**Stannah Model GL 229/228 - Requirement for Modification
Fitting of Halfen Bolts - Stannah Straight Stairlifts**

FITTING OF HALFEN BOLTS - STANNAH STRAIGHT STAIRLIFTS

STANNAH MODEL GL 229/228 - REQUIREMENT FOR MODIFICATION

RETROFIT PROCEDURE - GL CHAIR FIXING SCREWS

"HALFEN" FIXING BOLT PROCEDURE

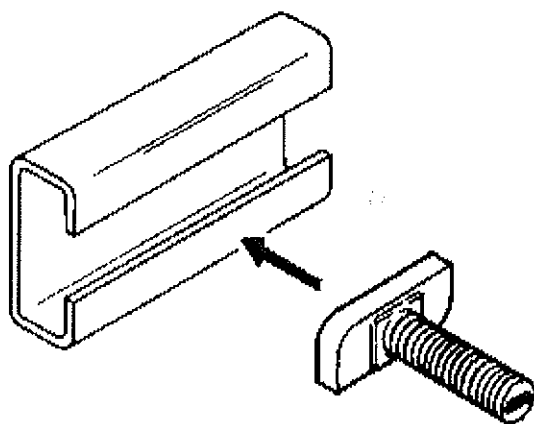
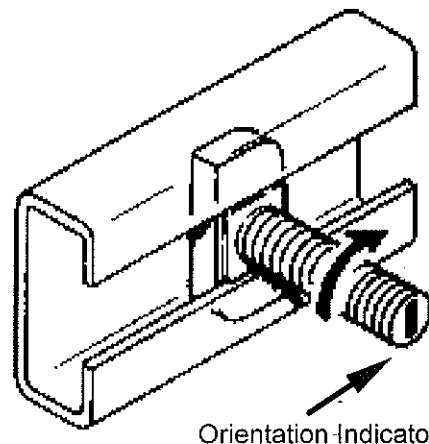
A recent safety incident on a 215 seat has highlighted the need to ensure that all "Halfen" fixing bolts are correctly fitted in order to make them fully effective.

The following diagram shows the correct orientation of the "Halfen" bolt head with respect to the "Halfen" channel.

It also shows the orientation indicator on the end of the threaded stud which **MUST ALWAYS BE AT A RIGHT ANGLE** to the "Halfen" channel before, during and after the nut is tightened.

Orientation before insertion into channel

90° rotation after insertion into channel.
Note orientation of indicator

This procedure applies to all "Halfen" fixings on all Stannah models.

These instructions are to be used in conjunction with Drawing No. 2294568

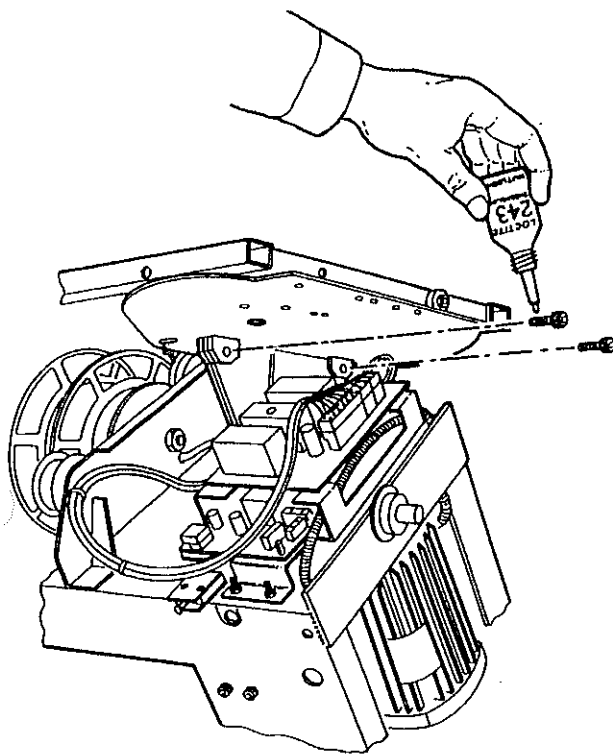
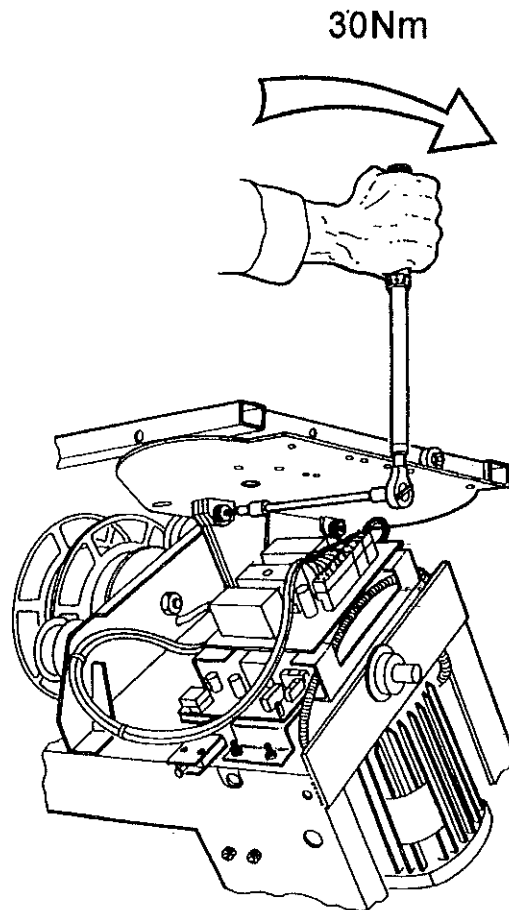
Following an incident where the seat fixings came loose and the chair tilted, we have reviewed the design and concluded that all 229 and 228 units sold since introduction in 1991 need to be checked and modified.

The attached procedure (Appendix 1) details the necessary work which involves replacement of the two seat fixing bolts with Tufloc bolts, the application of Loctite 243, the tightening of these bolts to 30 Nm and the fitting of a label to the carriage covers for future reference. We estimate that the time required on the premises is 10 minutes.

1. Unless this retro-fit is being carried out during a normal service, there is no need to remove the covers.
2. Remove one of the M8 Cap Screws that secures the chair to the carriage and discard the screw.
3. Replace with an M8x 25 long Tufloc Cap Screw (Part No. 2294566). This screw must be assembled with Loctite 243 and tightened to a torque of 30Nm (22lbf. ft), see Figs 1 & 2.
4. Repeat steps 2 & 3 for the remaining chair fixing screw.
5. Ensure that any excess Loctite is cleaned away.
6. Fit a chair fixing bolt label (Part No. 2294567) to the top of the covers as shown on Drawing No. 2294568.
